INDIANA UTILITY REGULATORY COMMISSION

CAUSE NO. 45367

TESTIMONY OF KRISTEN WILLOUGHBY

THE INDIANA OFFICE OF UTILITY CONSUMER COUNSELOR

### OUCG Attachment KW-01

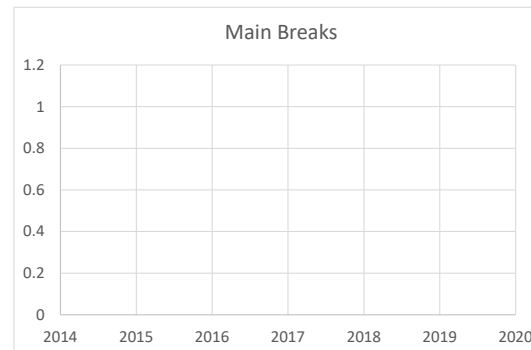
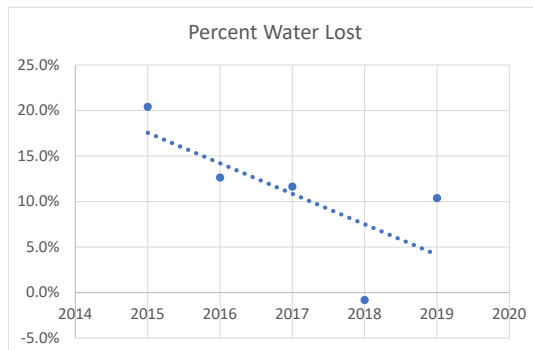
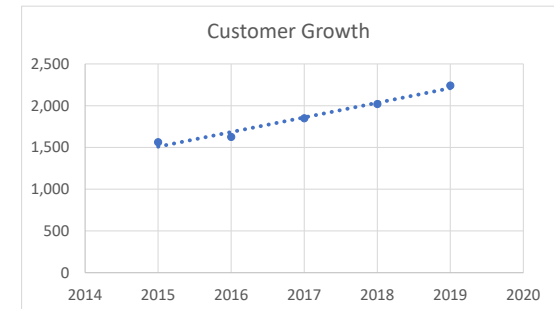
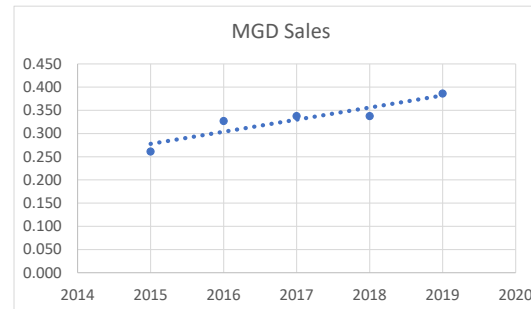
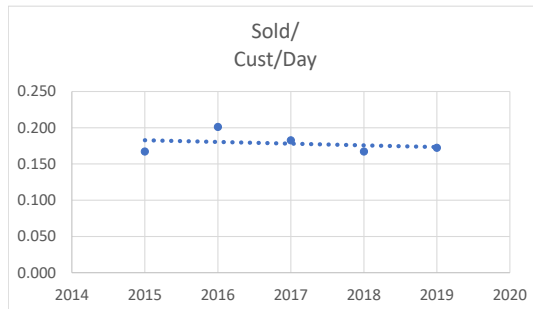
11 A: According to its IURC annual reports, over the last five years Cedar Lake's water  
12 loss values have decreased from 20.4% to 10.4% of water produced.<sup>8</sup> On page W-  
13 6 of its 2018 IURC annual report, Cedar Lake reported a negative water loss value.  
14 This appears to be a data recording or data entry error.

<sup>8</sup> See “Percent Water Loss” chart in Attachment KW-01.
